Subject: WPPSS NUCLEAR PROJECT NO. 2
RESPONSE TO QUESTIONS
SACRIFICIAL SHIELD WALL DESIGN

Reference: Letter, W.R. Butler to J.J. Stein, transmitting Request
for Additional Information dated July 8, 1974. (GI2-74-11)

SACRIFICIAL SHIELD WALL DESIGN SUPPLEMENTAL INFORMATION

WPPSS 74-2-R2-ATABLE OF CONTENTS

VIEW OF OUTBOARD FACE OF STEEL DOOR

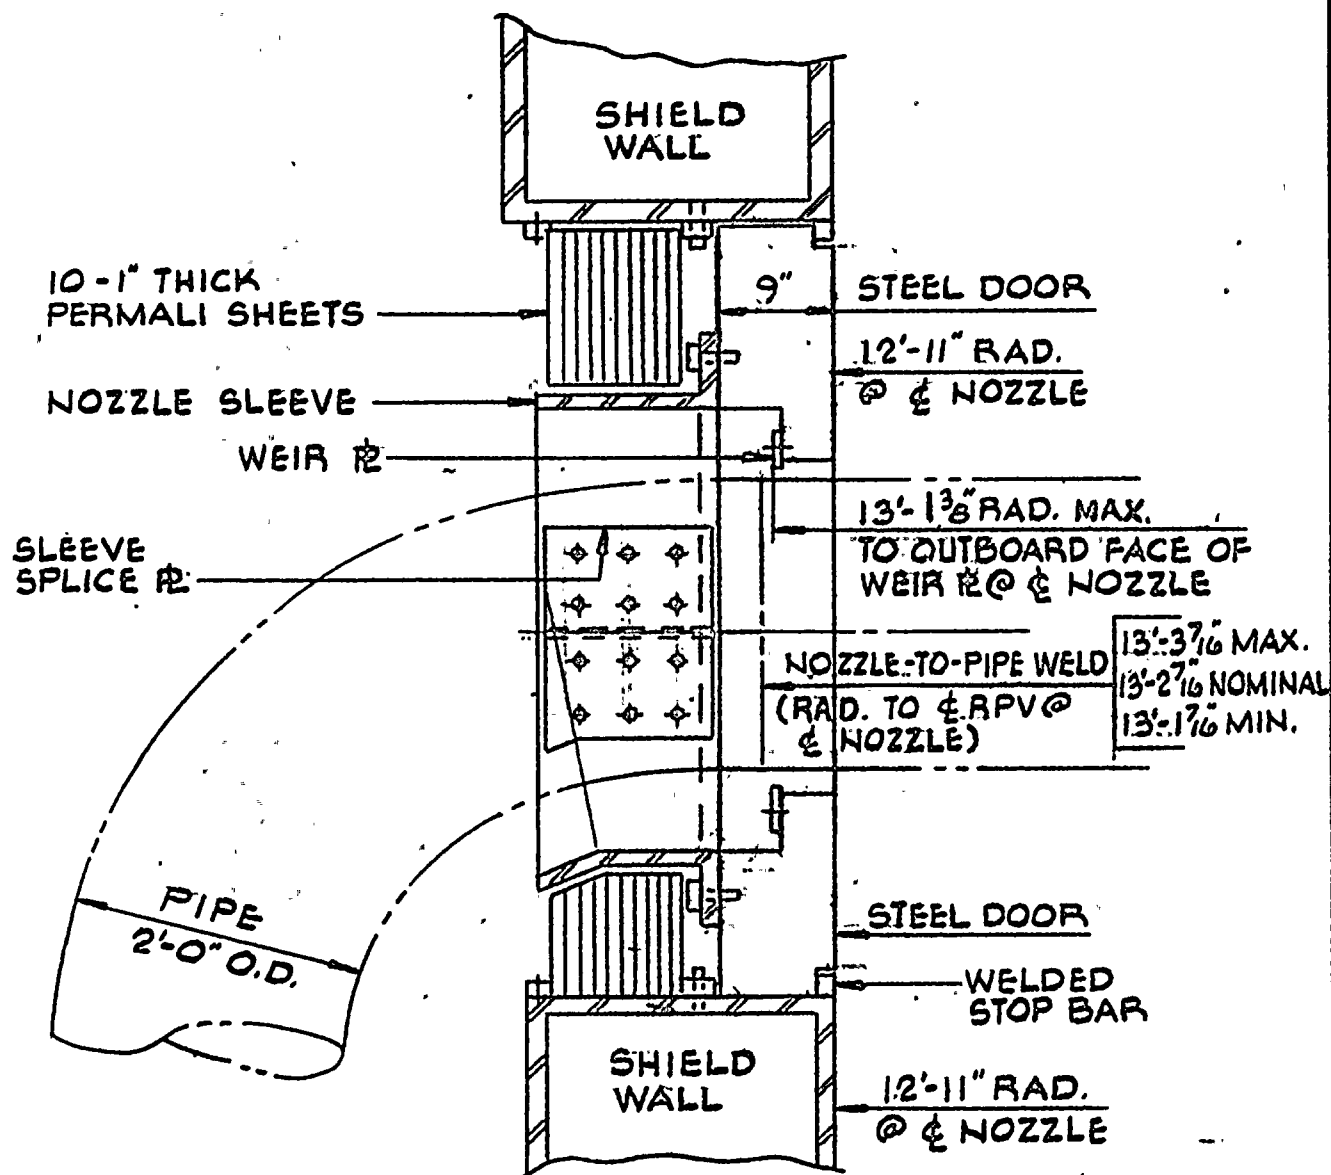
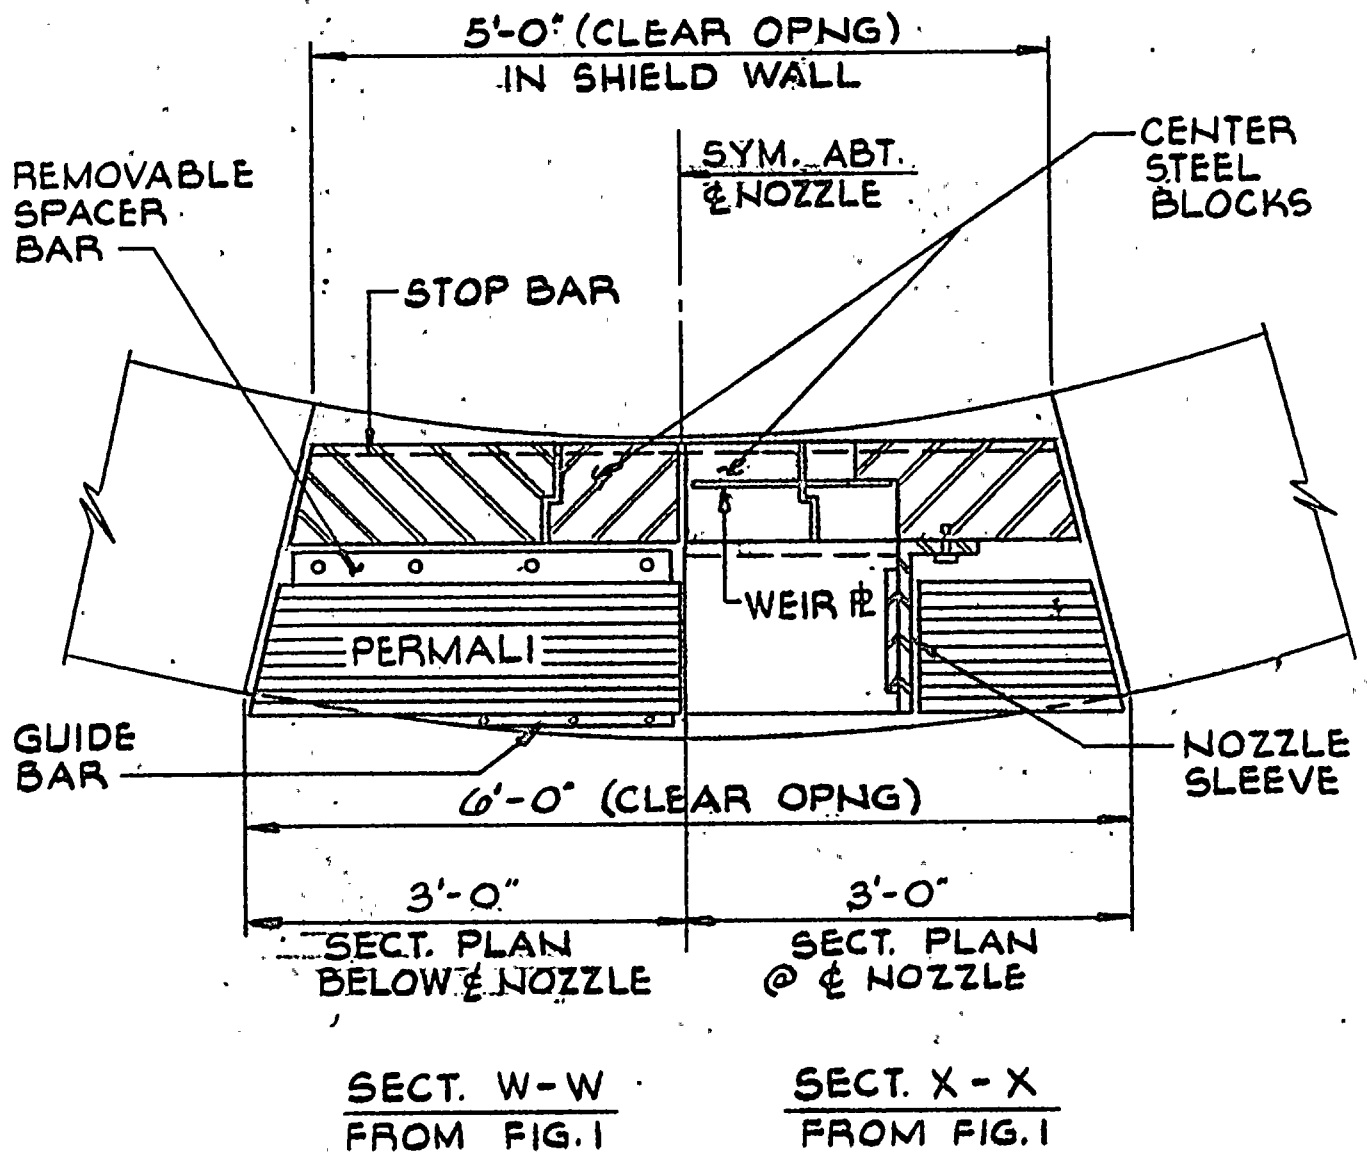
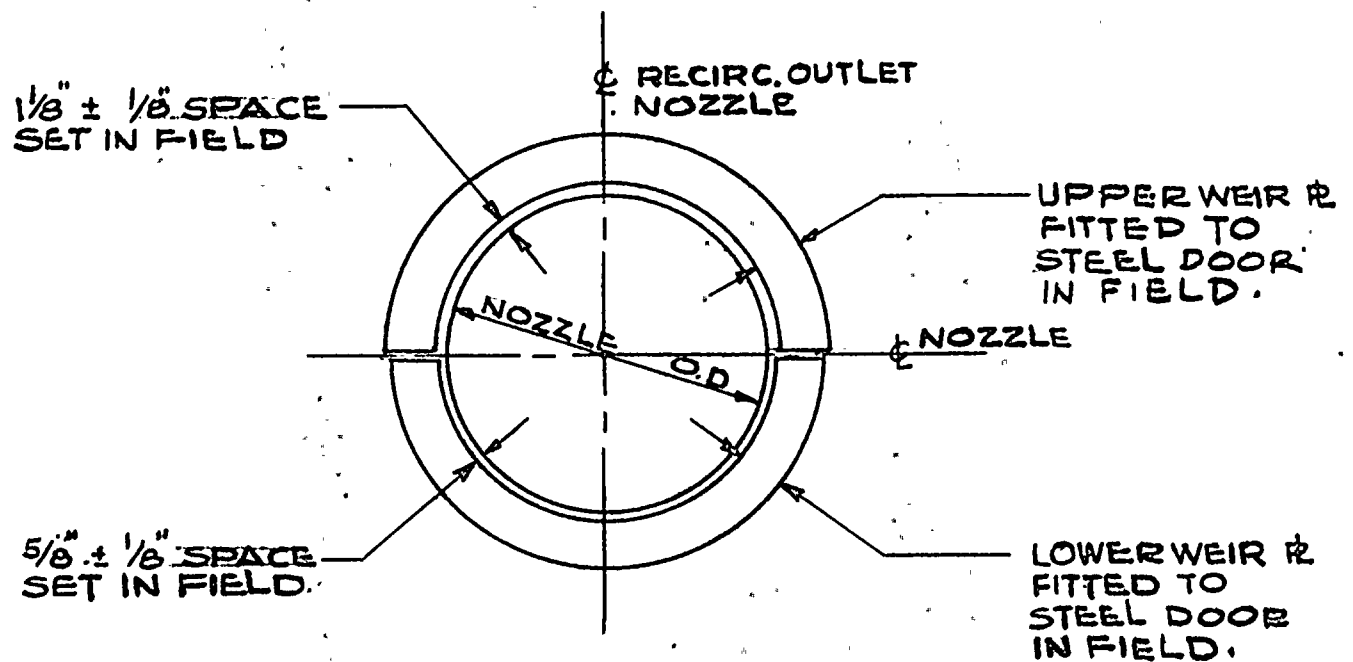
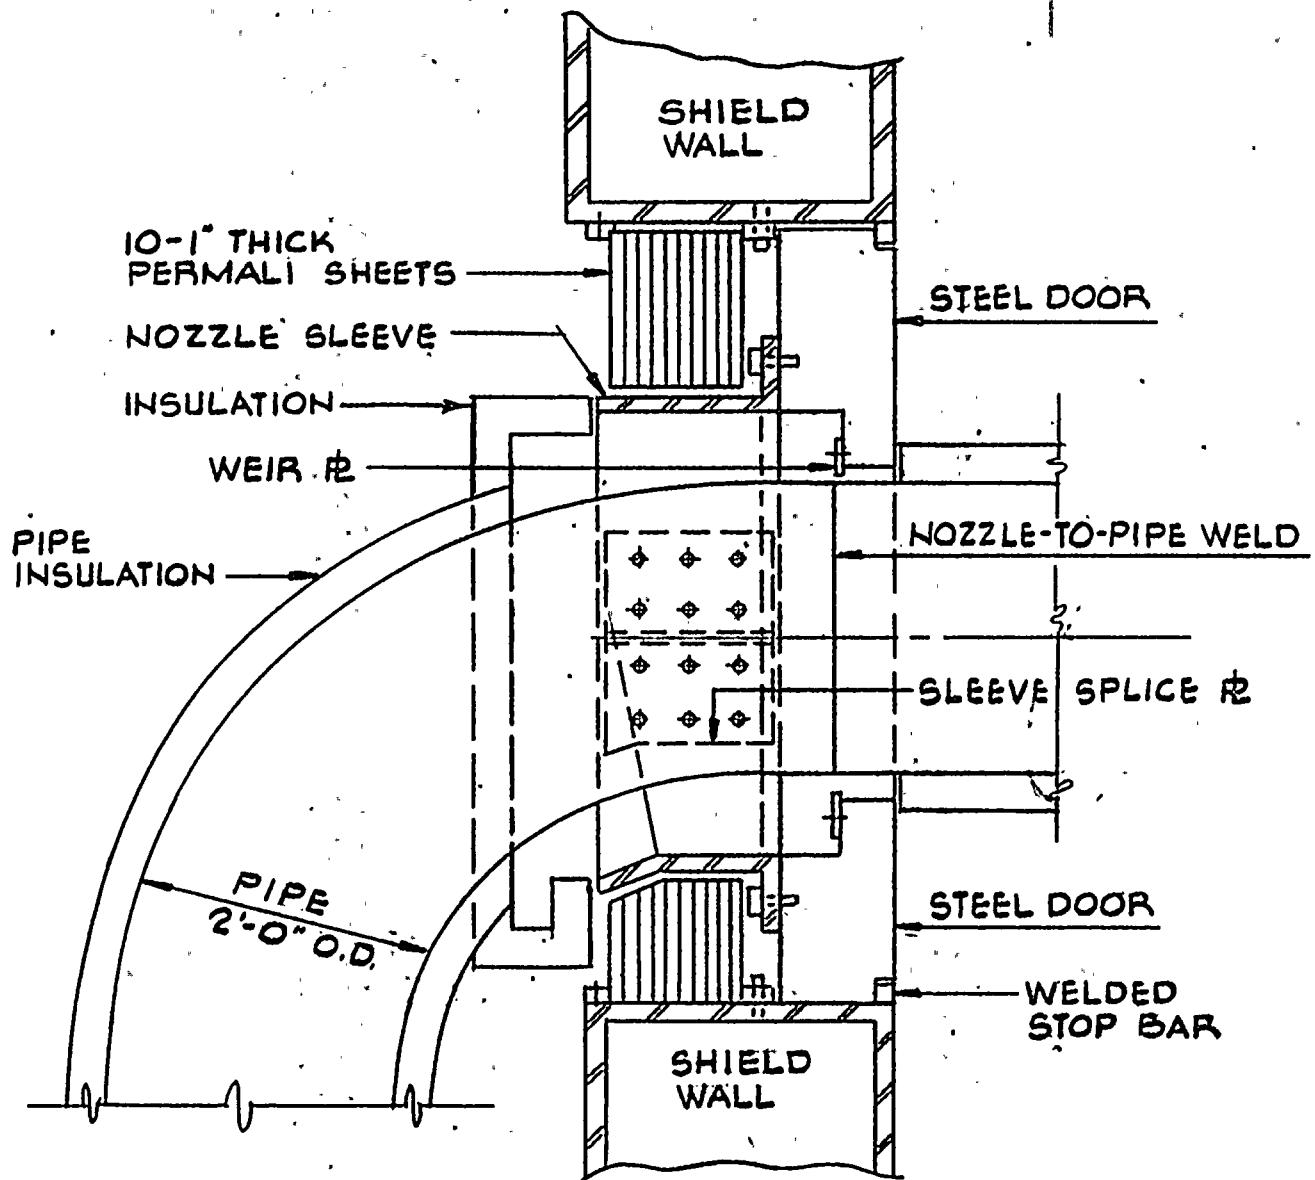
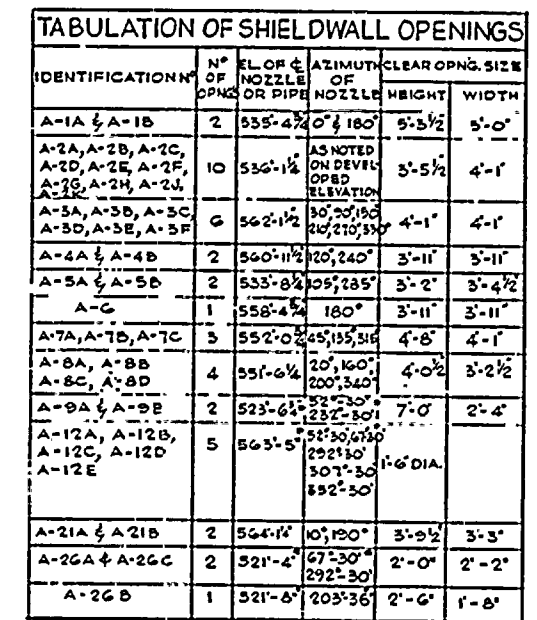
Provide a table of the blowdown mass and energy release rates used in the analysis.

Provide sufficiently detailed drawings showing the arrangement of the reactor vessel, sacrificial shield, insulation, and recirculation line from which subcompartment volumes and vent areas can be determined.

Only a portion of the blowdown will enter the annular space between the sacrificial shield wall and the reactor pressure vessel. Figures 1 through 3 illustrate the sacrificial shield wall flow limiting door design concept which results in the majority of the blowdown from the postulated break entering the drywell rather than the annulus. Conceptually, this design is illustrated in Figure 4. The fraction of blowdown which enters the shield wall annulus is based on the resistance to fluid flow through the restricted area of the doors as compared to the resistance to fluid flow toward the drywell. This is calculated as a function of the areas and flow coefficients in each direction away from the break.

For nominal door dimensions, the flow split is 8.6 to 1. The blowdown listed above is split between the drywell and the annulus by this ratio. Results of the pressure loading calculations from this flow split for the 60 node case discussed later in this report are shown in Figures 23 and 24. Also shown in Figures 23 and 24 are results based on a flow split of 7.5 to 1 representing the worst case tolerances for the weir plates (see Figures 1 and 2) which restrict flow into the annulus. Worst case tolerances for the weir plates are those which allow the largest area for flow to the annulus. Nominal and worst case fit-up for the weir plates are illustrated in Figure 5. Results of these two cases will be discussed later in this report.

180° FLAT DEVELOPMENT OF SHIELD WALL ANNULUS

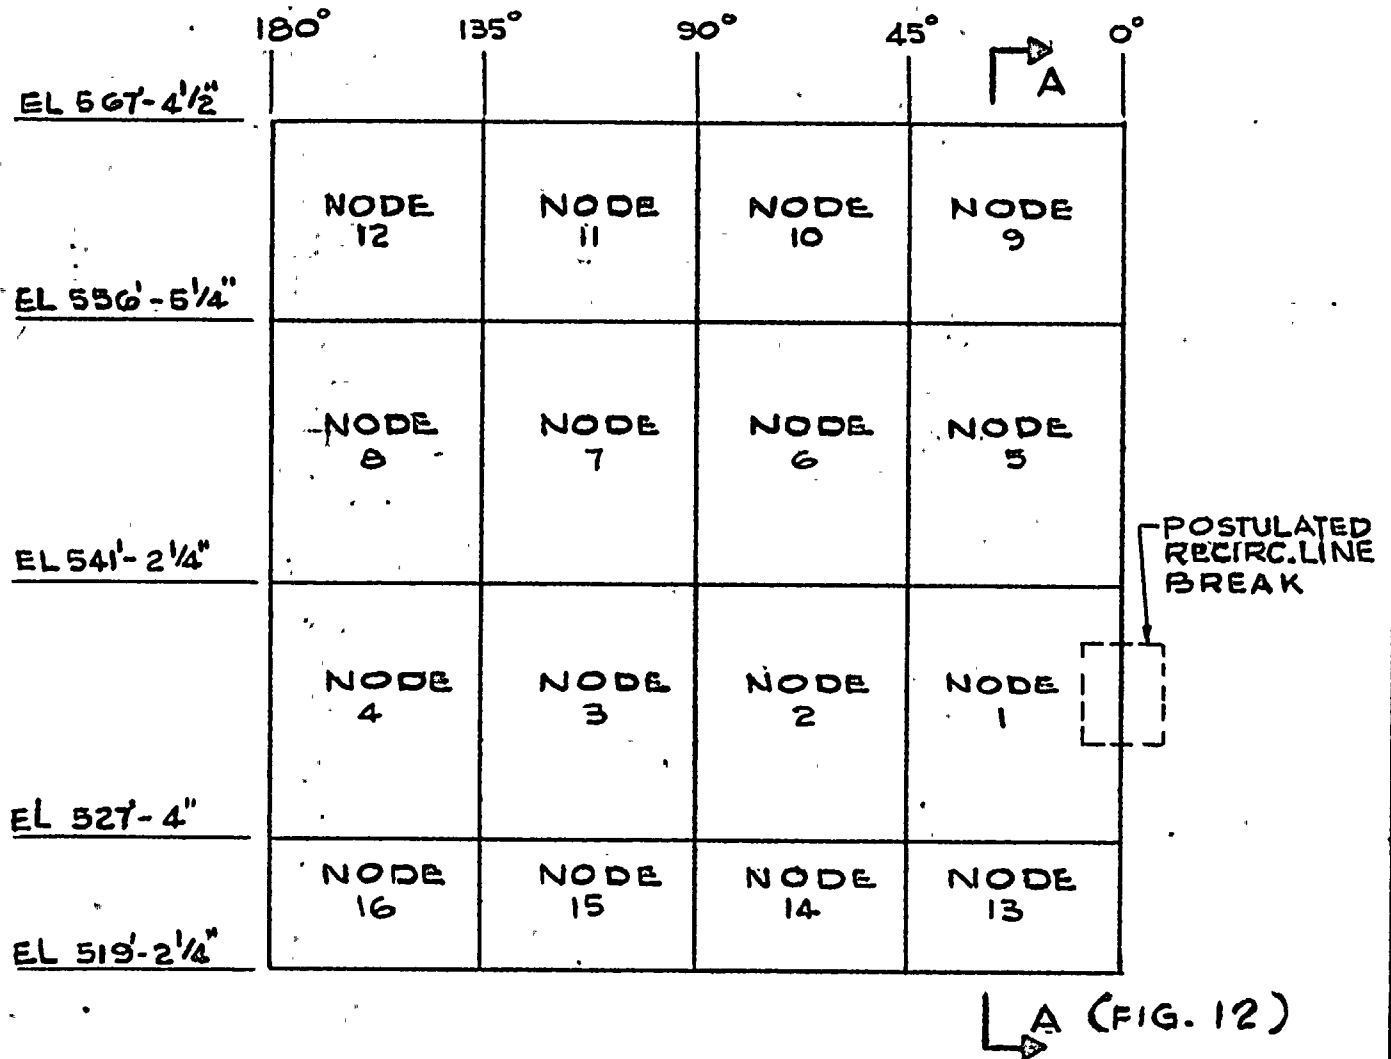
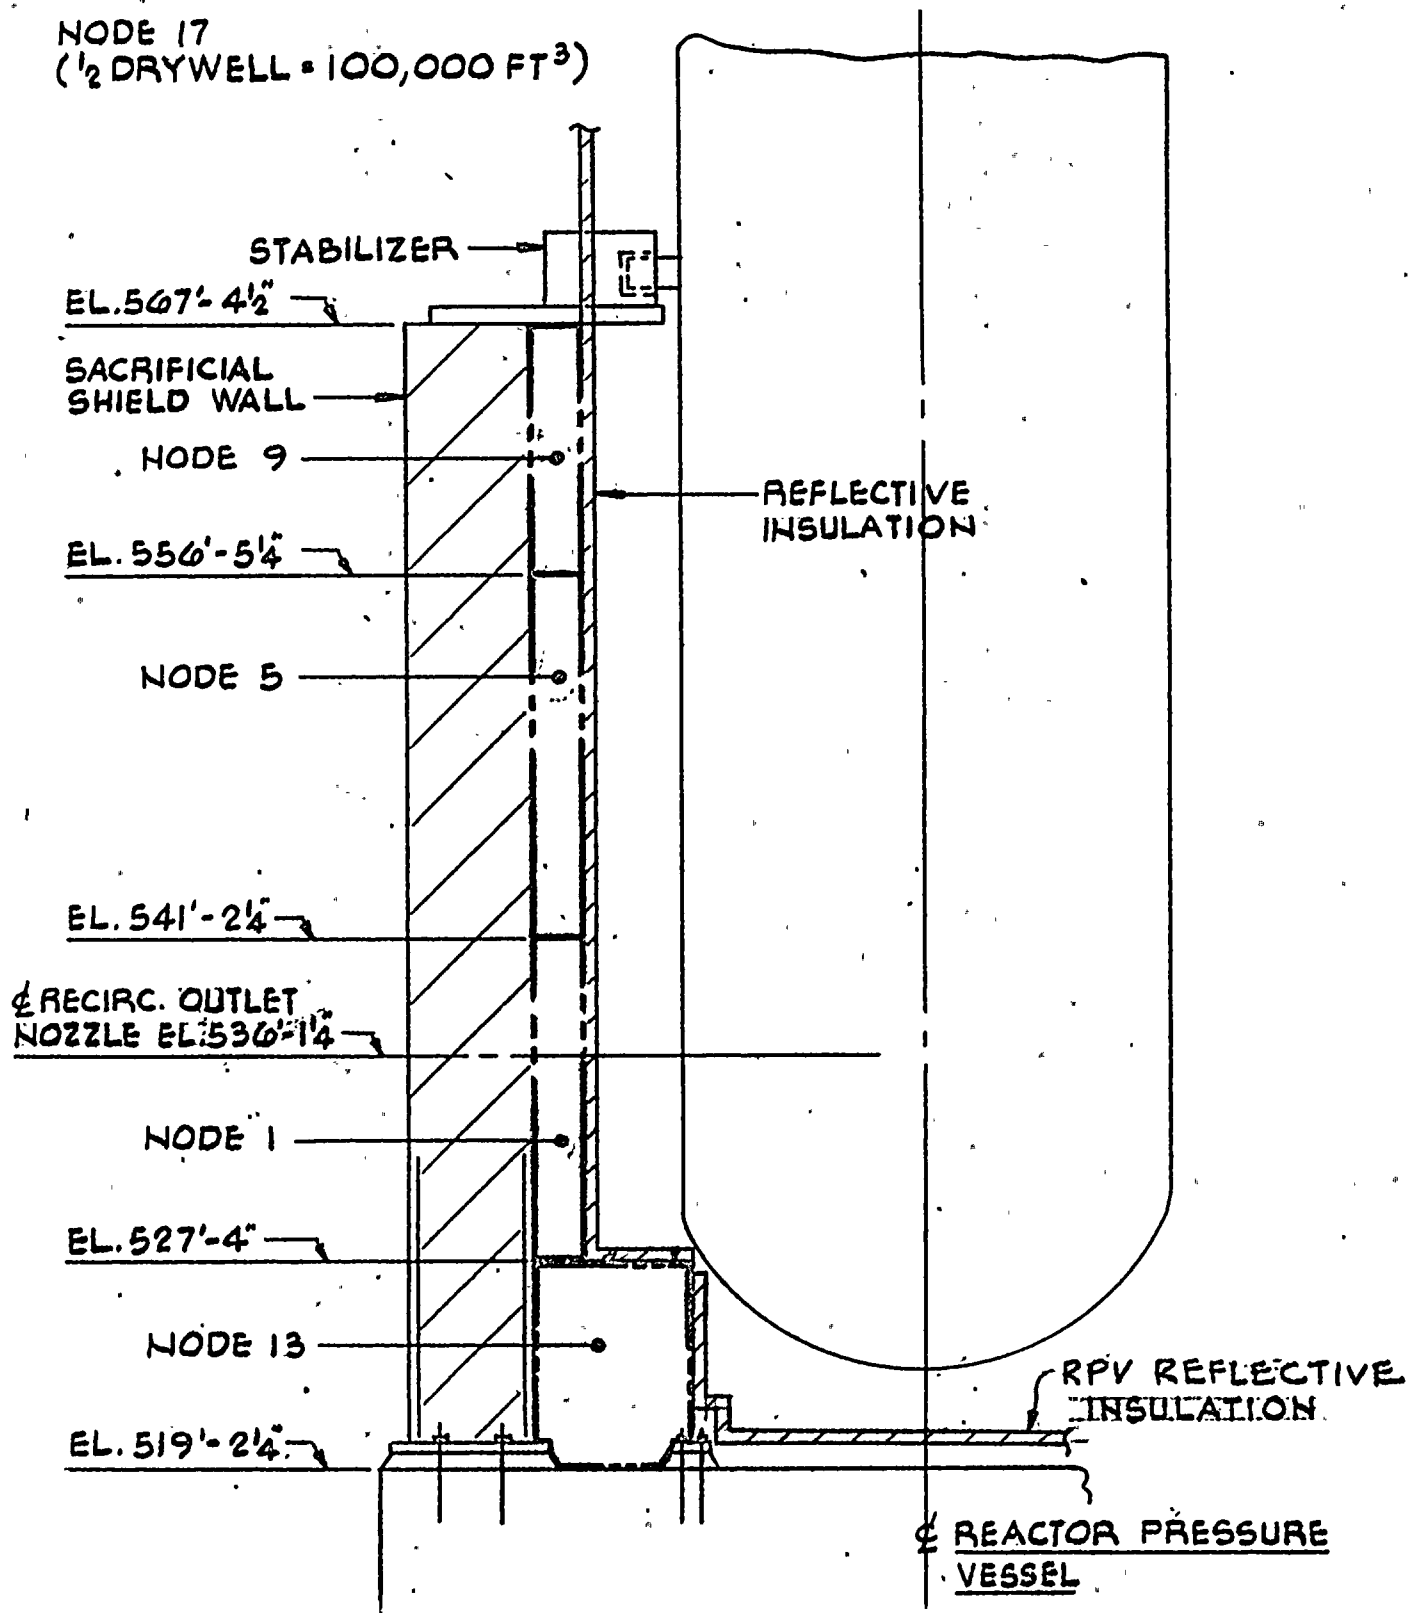
Describe the nodalization sensitivity studies performed to determine the minimum number of volume nodes required to conservatively predict the maximum pressure for the sacrificial shield annulus. These studies should include consideration of spatial pressure variations; i.e., pressure variations circumferentially, axially and radially within the annulus.

Figures 11 and 12 illustrate nodal volumes. The 17 nodes shown for this 180° arc correspond to a 34 node analysis of the complete annulus. Vent areas were taken as indicated in the response to Question 2c (through the stabilizer region and through openings A-3A through A-3F and A-4A and A-4B). Results of calculations for this 17 node case are given in Figure 13. Figure 13 shows the pressures in each node at the time of maximum shear force and moment at the base of the annulus.
